From: Simon O'Connell
Sent: 28 June 2021 14:04
To: [REDACTED]
Cc: Darek Podwiazka
Subject: Cambridge Road Sponsor review
Attachments: 210625 LSP SR Cambridge Road Rev S2-P01.xlsx

Sponsor Review Form

| Route Name | Cambridge Road LSP Cycle Scheme |
| Scheme Reference Number | 70014694-01-WSP-PO1-X-DR-HI-0100 |

TITLE
GO CYCLE EASTERN ROUTE
GENERAL ARRANGEMENT
SHEET 01 OF 10

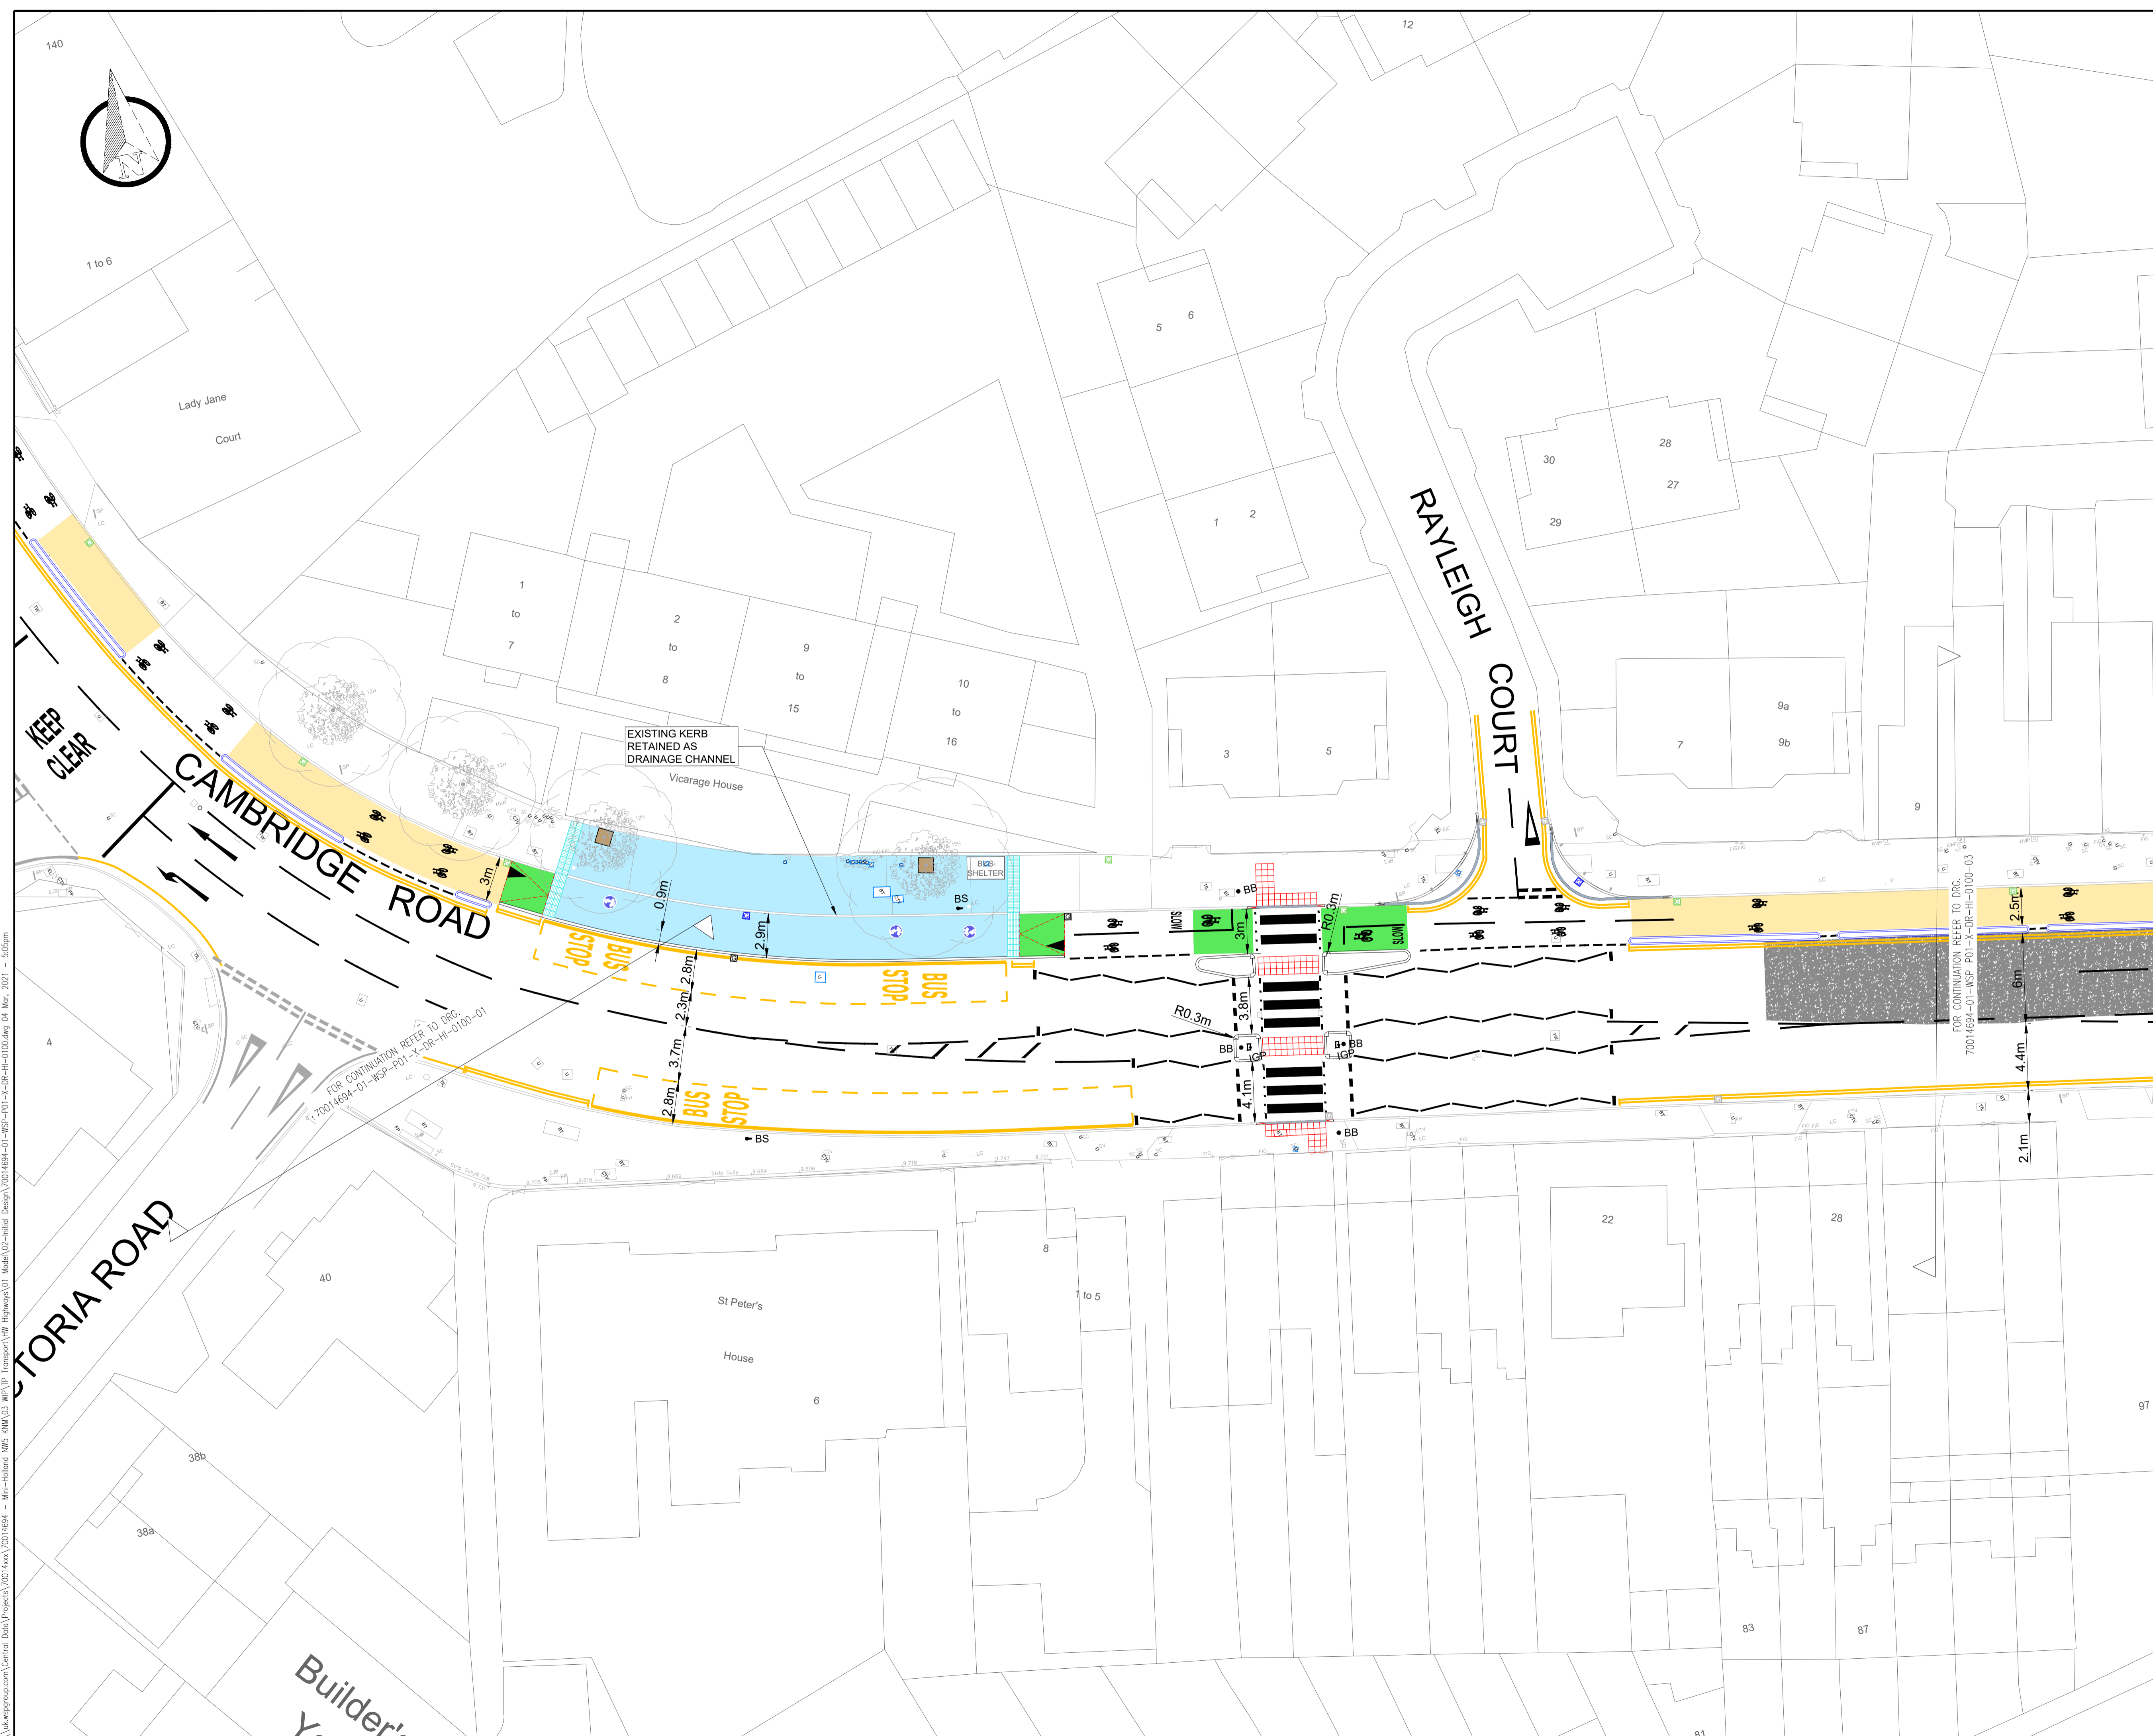
| SPONSOR TO COMPLETE | | | | | | | DESIGNER TO COMPLETE | | |
|---------------------|--|--------|------------------------|--------------------------------|----------------|---|--------------------------------|------------------|-------------------|
| 1 | 70014694-01-WSP-PO1-X-DR-HI-0100-01 | S1-P01 | GO CYCLE EASTERN ROUTE | Andy McMurdo (TfL Engineering) | 29/01/2021 | What are northbound cyclists connecting into at the junction with London Road? | | | |
| 2 | 70014694-01-WSP-PO1-X-DR-HI-0100-01 | S1-P01 | GO CYCLE EASTERN ROUTE | Richard Pink (TfL Engineering) | 01/02/2021 | Unsure how the raised track / footway ties into the existing. Has vehicle tracking been carried out for the left and right turn movements from London Road onto Cambridge Road? | | | |
| 3 | 70014694-01-WSP-PO1-X-DR-HI-0100-01&02 | S1-P01 | GO CYCLE EASTERN ROUTE | Richard Pink (TfL Engineering) | 01/02/2021 | Are the existing bus lanes being removed? If so are there any impacts on the bus journey times? Have TfL Buses being consulted? | | | |

| 70014694-01-WSP-P01-X-DR-HI-0100-02 | S2-P01 |

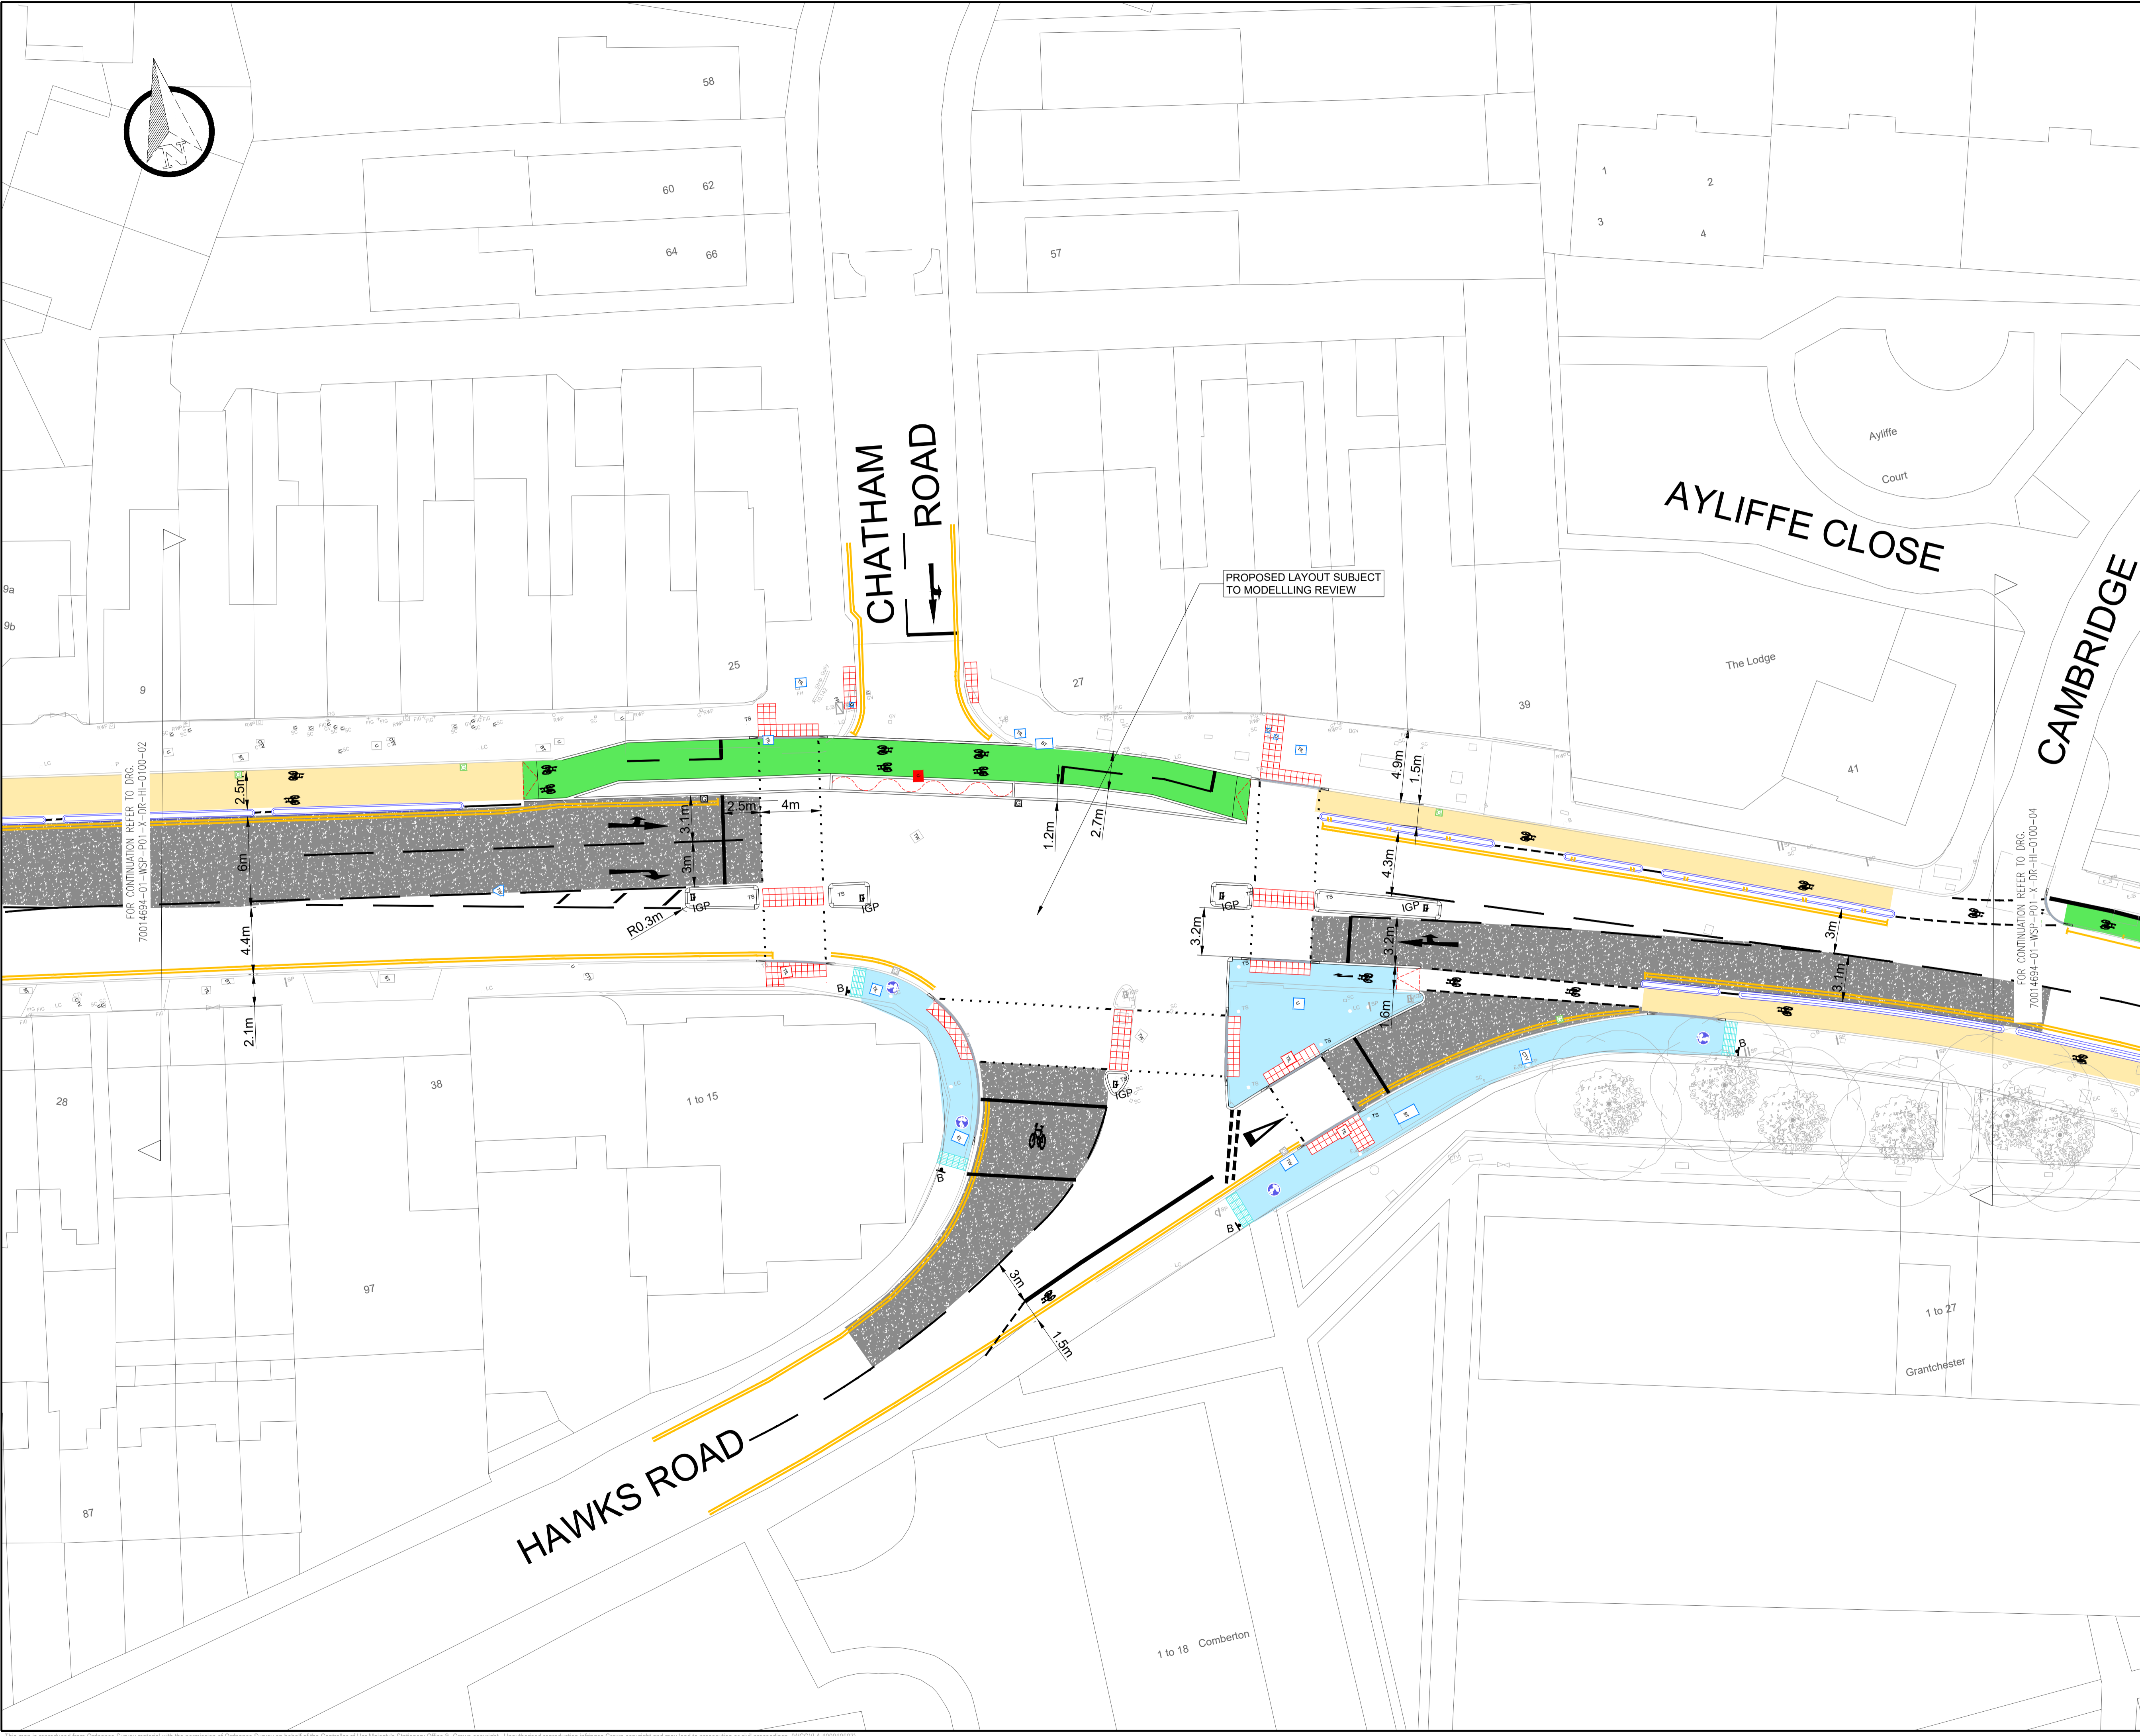
| SPONSOR TO COMPLETE | | | | | | | DESIGNER TO COMPLETE | | |
|---------------------|--|--------|------------------------|--------------------------------|----------------|---|--------------------------------|------------------|-------------------|
| 4 | 70014694-01-WSP-PO1-X-DR-HI-0100-02 | S1-P01 | GO CYCLE EASTERN ROUTE | Andy McMurdo (TfL Engineering) | 29/01/2021 | What are the passenger numbers at the stop west of Rayleigh Court? | | | |
